***PROPOSED MODIFICATION:
Werris Creek Coal Mine
(DA 172-7-2004 MOD 5)***

Environmental Assessment Report
Section 96(2) of the
*Environmental Planning and Assessment
Act 1979*

September 2009

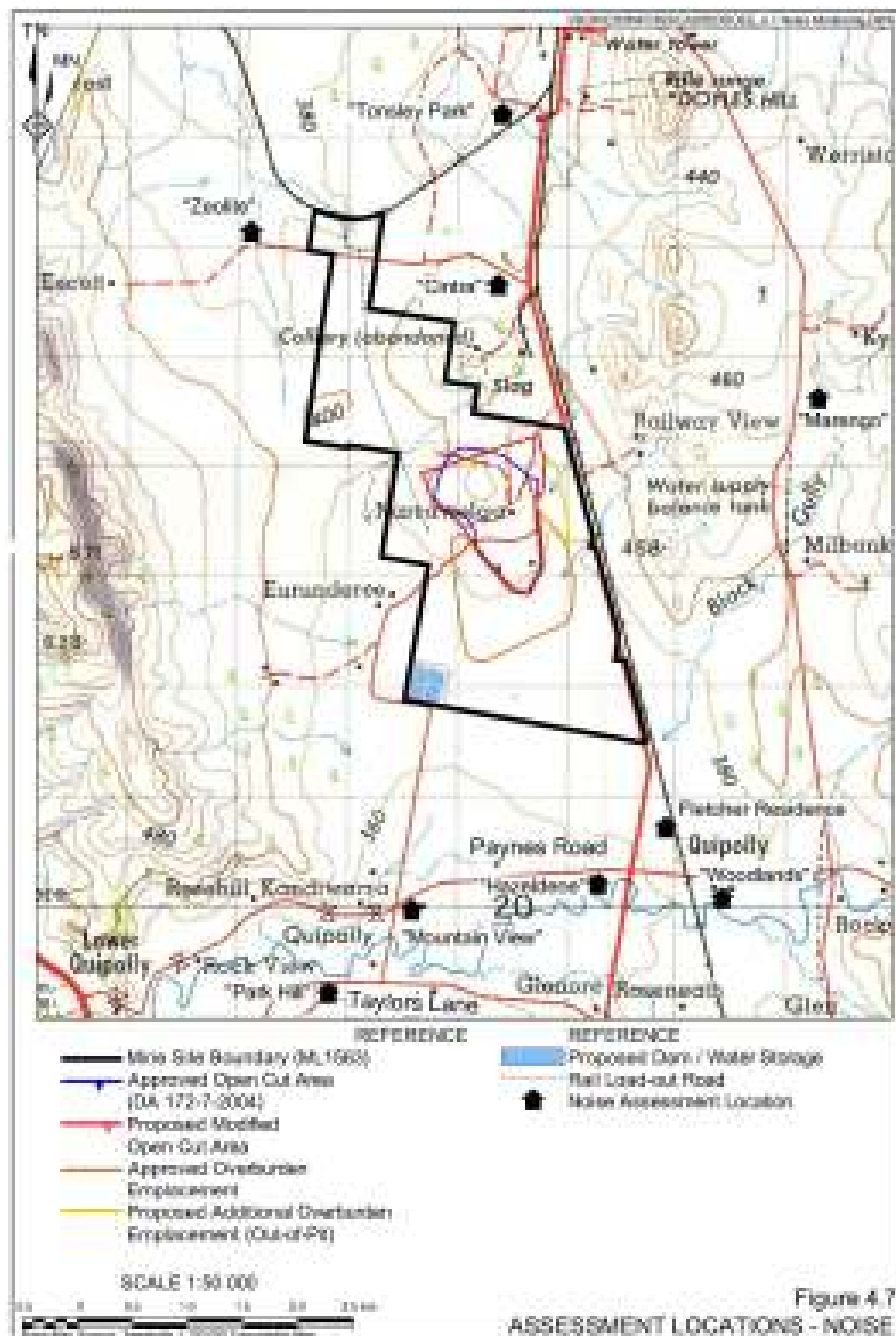
The proposed modification has the potential to generate construction, operational, on-site traffic and rail-related incremental and cumulative noise impacts. A noise assessment for the proposal was undertaken by Spectrum Acoustics Pty Limited (Spectrum) with reference to the *NSW Industrial Noise Policy* (INP), and to relevant sections of the Environmental Noise Control Manual (ENCM) in respect of rail traffic. Since construction activities would be undertaken concurrently with the continued operation of the Werris Creek Coal Mine, a separate construction noise assessment was not undertaken and a construction noise criterion has therefore not been set. The assessment was based on computer model predictions undertaken for three ‘worst-case’ operational scenarios at the closest non-project related residences (refer Figure 4).

The assessment indicates that under most conditions, the 35 dB(A) noise criterion could be achieved and would not exceed 40 dB(A) at the “Cintra” residence. A minor exceedance of 1 dB(A) is predicted at the “Tonsley Park” residence during inversion conditions, if soil stripping activities are undertaken concurrently with surface drilling and other mining activities. Exceedances of 1 and 3 dB(A) are also predicted at the “Hazeldene” and “Fletcher” residences respectively under northwest wind conditions when the OEA is at its maximum proposed height. The assessment also predicted that maximum noise levels would not exceed the sleep disturbance criteria of 45 dB(A)_{L_{max}} for the mining scenarios modelled.

Because of the increased elevation at which mining activities would occur relative to nearby residences, the Department believes that WCC should prepare an updated noise management plan to incorporate the measures outlined above. Additionally, since the noise predictions are close to, and in some cases exceed the operational noise criterion, the Department believes that residents should also be provided with some protection in the event that noise generated by the proposed modification exceeds predicted noise levels.

In order to mitigate the modelled operational noise exceedances, WCC has committed to the following:

fashion. However, the Department considers that WCC should also be required to offer architectural treatment to residences where noise monitoring shows that project-related noise is equal to or exceeds 38 dB(A). The Department has recommended a condition of consent to achieve this outcome.

Figure 5: Plan and Sections of Approved and Proposed Final Landform

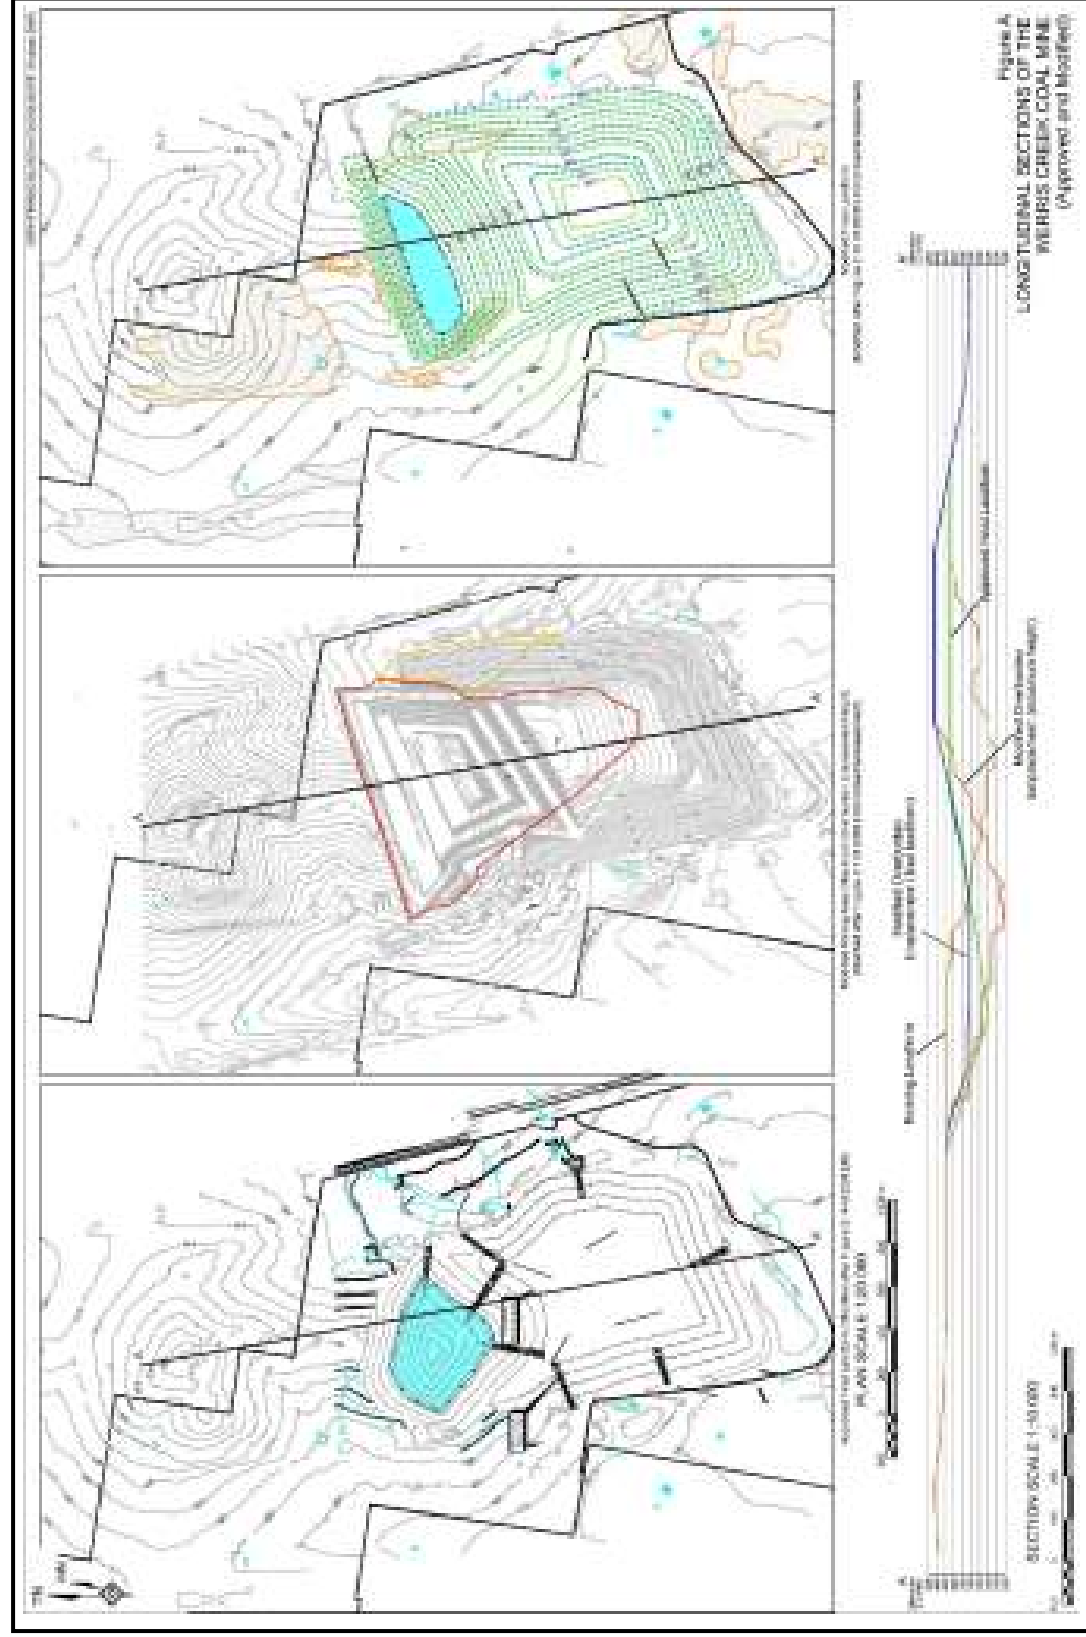
The proposed modification has the potential to affect local visual amenity since it is proposed to increase the final landform to a height of 445 m, approximately 65 m above natural ground level. The approved and proposed final landforms and the corresponding cross-sections are shown in Figure 5.

While the proposed height increase of the OEA is regarded as significant, WCC considers that the final landform would appear as a continuation of the existing north-south oriented ridge located within the mine site (refer to the sections in Figure 5). Further, the proposed progressive rehabilitation of the slopes is anticipated to assist in blending the OEA with the surrounding landscape.

The modification application sought to increase the height of the OEA to 436 m AHD. WCC made a later submission to the Department seeking approval to increase the maximum height of the OEA to 445 m AHD (refer Figure 5). WCC provided the results of revised noise modelling which took the increased maximum height into account. These results were the basis of the Department's noise assessment above.

Overburden from the open cut must be emplaced somewhere on the mine site. The essential question for the assessment is whether the OEA should be higher (i.e. 445 m AHD) or larger in footprint. The increased height would have very limited visual impacts either for residents of the properties located 2.5 - 3.5 km to the south or to travellers on the Werris Creek-Quirindi Road. The Department sought photo montages of the proposed final landform which supported this. The Department therefore accepts the proposed increase in height and is satisfied that the impacts on visual amenity would not be significant.
